Sleep Inn Hotel

**CITY OF PORTLAND, MAINE
DEVELOPMENT REVIEW APPLICATION
PLANNING DEPARTMENT PROCESSING FORM
Planning Department Copy**

RE: Site Plan Review
Warehouse Facility
160 Riverside Street

Attached for your review and consideration are revised plans and Stormwater Management Report to address the comments raised by staff and the Portland Pipeline Corporation. Our revisions are as follows:

1 VERTICAL CURB INSTALLATION DETAIL
NOT TO SCALE

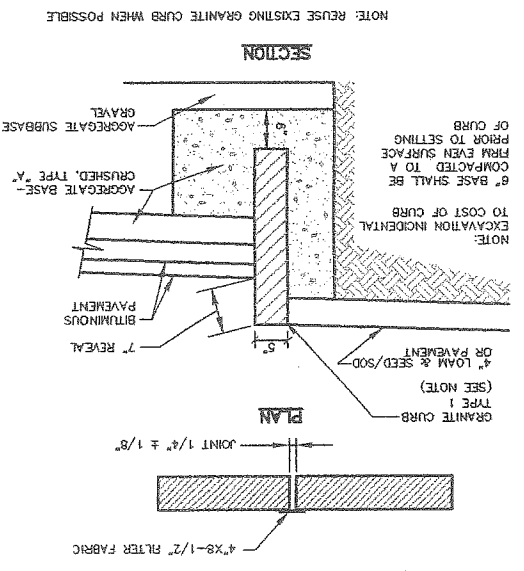
Applicant must provide a detail specific to the installation of granite curb in the Riverside Street right of way. This detail must be drawn to City of Portland Design and Technical Standards.

1. A Stormwater Management Report has been submitted to Jim Wendel at Deluca-Hoffman for review. Mr. Wendel has commented on the report and our response to his comments is attached.
2. A detail of the granite curb installation on Riverside Street is attached on Sheet D2, Detail #1.
